Objection to Indigo by Moran Seniors Living (SSD-76220734)

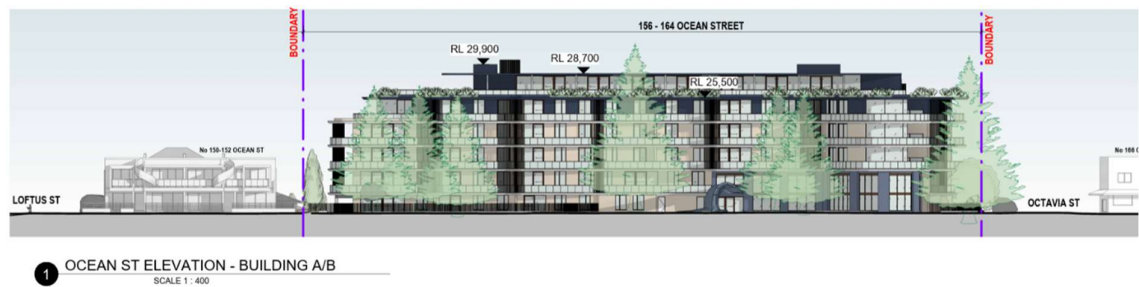
How the developer can say that ***“The siting of the building respects the neighbourhood’s residential character, minimising adverse impacts on the streetscape or adjacent properties”*** is totally misleading. How can a 6 storey building not impact the streetscape or adjoining properties!

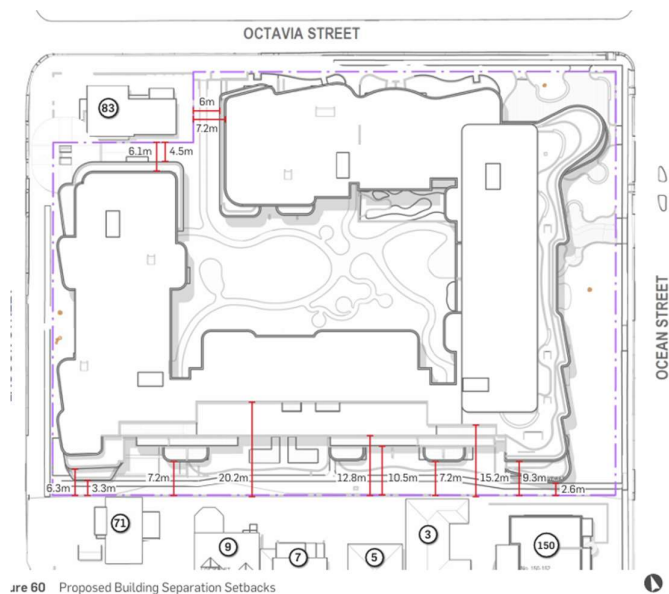
As shown below, the setback to 150 Ocean Street is 2.6m from the end of the balcony. How can this give our property any privacy, particularly to the owners of Units 4 and 8.

South Interface with 150 Ocean Street:– North facing windows are visible on the neighbouring facade, where a minimum of 2.6m setback is proposed for the south-eastern balconies from Ground Level to Level 3.

The above statement is incorrect. The setback along the south boundary range from 2.3m to 12.8m as shown in the above diagram in item 4. As such, I believe that the shadow diagrams that accompany the proposal are inaccurate. The scale of the development will I believe shade my rooftop terrace substantially in the winter months when the sun is lower in the sky. I would ask that an independent shadow diagram report be obtained to substantiate this.

Propose that the balconies on the souther side be deleted so that the setback would be 9.3m.
